# LAND USE APPLICATION FORM

**File Number(s):** GLUA-21-00001 and HR-21-00001 through HR-21-00005

Project Name: Canemah Cottages Number of Lots Proposed (If Applicable): \_\_\_\_\_

## TYPE III –HISTORIC REVIEW BOARD SUBMITTAL

North (side) elevation

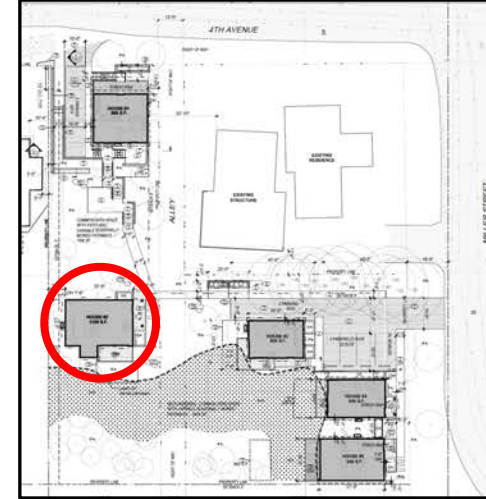
Changes from HRB approval	Compatibility Proposed Mitigation
Window placement/spacing	Windows grouped similarly to application; Compatible w/historic guidelines
Siding is textured hardie plank, not wood	Actual wood cost prohibitive; Compatible w/Historic Guidelines. Texture not visible from ROW.
Skylight may be visible from ROW. Need to see it with landscaping installed.	Skylight will be obscured by tree in landscape area and is low profile/inconspicuous
Window member sizing, thickness, and shadowline does not match painted wood windows	Add 1" to Window Trim - only on elevations directly adjacent to ROW

South (side) elevation

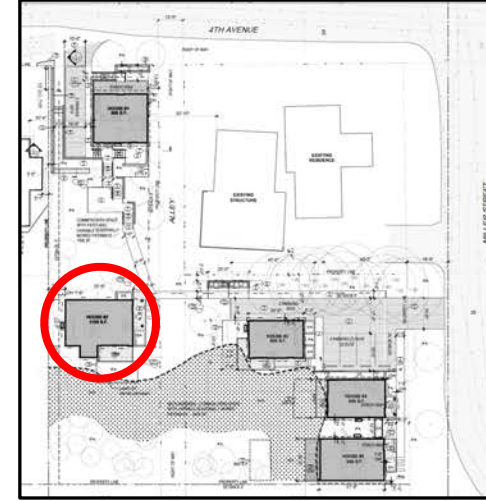
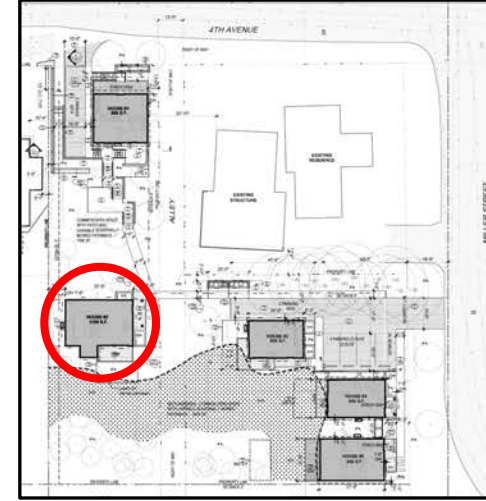
Changes from HRB approval	Compatibility Proposed Mitigation
Window on left side missing	compatible w/historic guidelines; not visible from ROW
Siding is textured hardie plank, not wood	Actual wood cost prohibitive; Compatible w/Historic Guidelines. Not visible from ROW
Window member sizing, thickness, and shadowline does not match painted wood windows	Add 1" to Window Trim - only on elevations directly adjacent to ROW
Removal of side porch roof and stair	Entry Moved to east elevation; Compatible w/historic guidelines

South (side) elevation - facing wetland

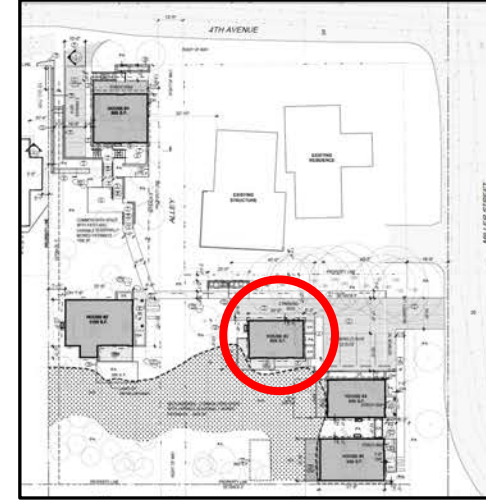
Changes from HRB approval	Compatibility Proposed Mitigation
Siding is textured hardie plank, not wood	Actual wood cost prohibitive; Compatible w/Historic Guidelines. Not visible from ROW
Window member sizing, thickness, and shadowline does not match painted wood windows	Add 1" to Window Trim - only on elevations directly adjacent to ROW
Vertical siding changed to horizontal (COA was to not face public streets)	Changed to be consistent with all homes/all elevations. Compatible w/historic guidelines

## East (front) elevation

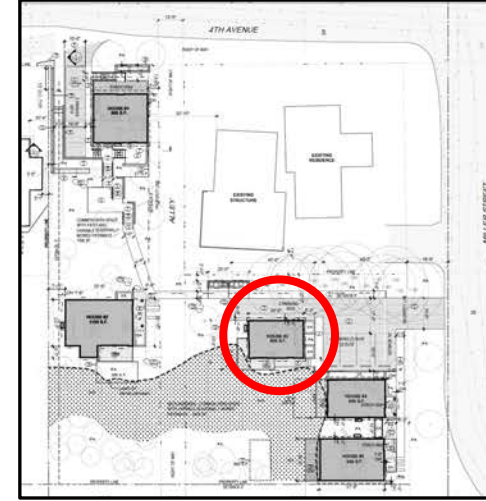
Changes from HRB approval	Compatibility Proposed Mitigation
Entry moved to south elevation	to accommodate parking and storm planters; Compatible w/ historic guidelines; lower facade will have landscape cover to break up facade
Siding is textured hardie plank, not wood	Actual wood cost prohibitive; Compatible w/Historic Guidelines. Not visible from ROW
Window member sizing, thickness, and shadowline does not match painted wood windows	Add 1" to Window Trim - only on elevations directly adjacent to ROW
Vertical siding changed to horizontal (COA was to not face public streets)	Changed to be consistent with all homes/all elevations. Compatible w/historic guidelines

## West (rear) elevation

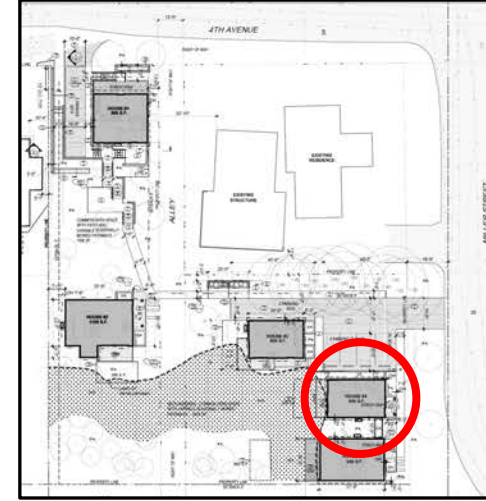
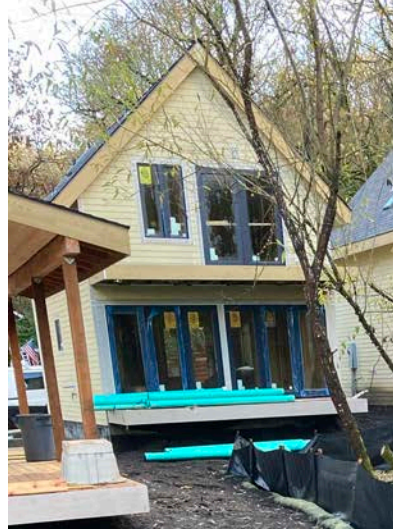
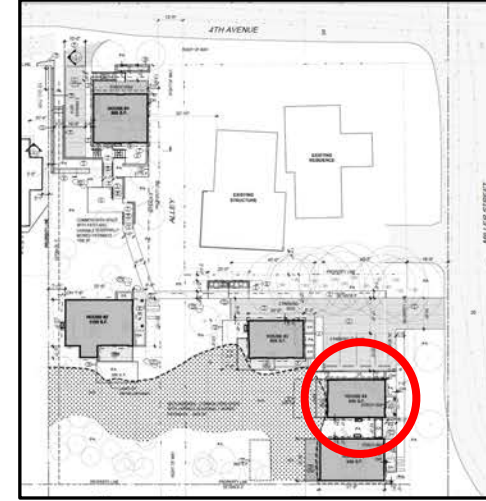
Changes from HRB approval	Compatibility Proposed Mitigation
Siding is textured hardie plank, not wood	Actual wood cost prohibitive; Compatible w/Historic Guidelines. Not visible from ROW
Window member sizing, thickness, and shadowline does not match painted wood windows	Add 1" to Window Trim - only on elevations directly adjacent to ROW
Vertical siding changed to horizontal (COA was to not face public streets)	Changed to be consistent with all homes/all elevations. Compatible w/historic guidelines

## South (side) elevation

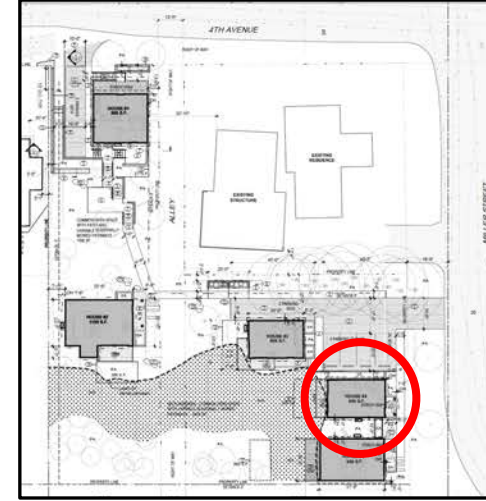
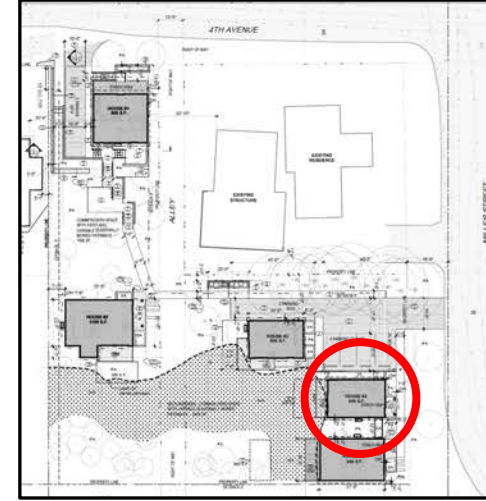
Changes from HRB approval	Compatibility Proposed Mitigation
Larger/paired windows	More windows added for natural light; Compatible w/historic guidelines
Siding is textured hardie plank, not wood	Actual wood cost prohibitive; Compatible w/Historic Guidelines. Not visible from ROW
Window member sizing, thickness, and shadowline does not match painted wood windows	Add 1" to Window Trim - only on elevations directly adjacent to ROW
Skylights are visible from ROW	Skylights are compatible w/historic guidelines, "Skylights shall not face ROW"

**House #4**  
*East (front) elevation*

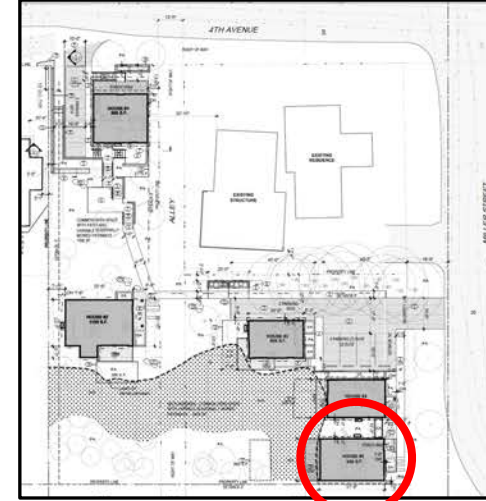
Changes from HRB approval	Compatibility Proposed Mitigation
Siding is textured hardie plank, not wood	Actual wood cost prohibitive; Compatible w/Historic Guidelines. Not visible from ROW
Window member sizing, thickness, and shadowline does not match painted wood windows	Add 1" to Window Trim - only on elevations directly adjacent to ROW
Skylights are visible from ROW	Skylights are compatible w/historic guidelines, "Skylights shall not face ROW"

**House #5**  
*East (front) elevation*

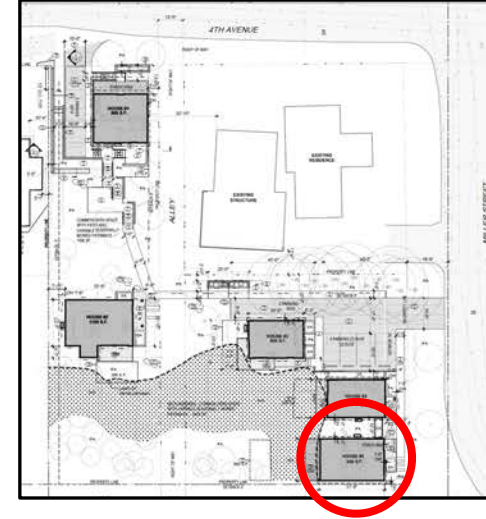
Changes from HRB approval	Compatibility Proposed Mitigation
Window placement	Compatible w/Historic materials Guidelines.
Siding is textured hardie plank, not wood	Actual wood cost prohibitive; Compatible w/Historic Guidelines. Not visible from ROW
Window member sizing, thickness, and shadowline does not match painted wood windows	Add 1" to Window Trim - only on elevations directly adjacent to ROW
Porch add on rather than cut out	changed to make homes consistent; Compatible w/Historic Guidelines.

**House #5**  
*North (side) elevation*

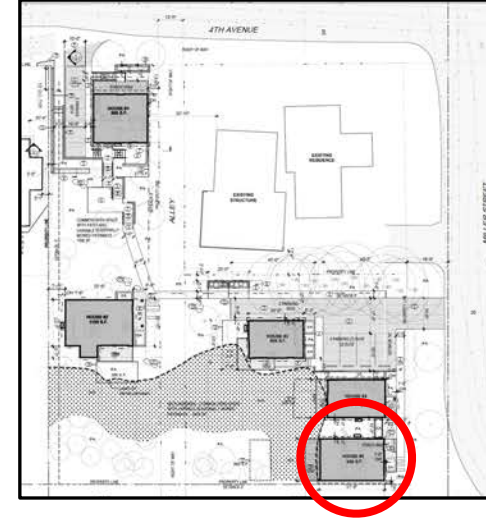
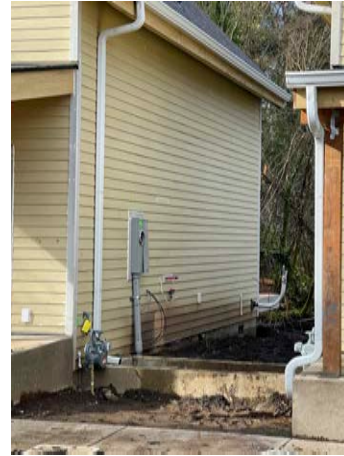
Changes from HRB approval	Compatibility Proposed Mitigation
No windows on this facade	Add 36" Square Window
Window Shadowline	Add 1" to Window Trim - only on elevations directly adjacent to ROW
Siding is textured hardie plank, not wood	Actual wood cost prohibitive; Compatible w/Historic Guidelines. Not visible from ROW
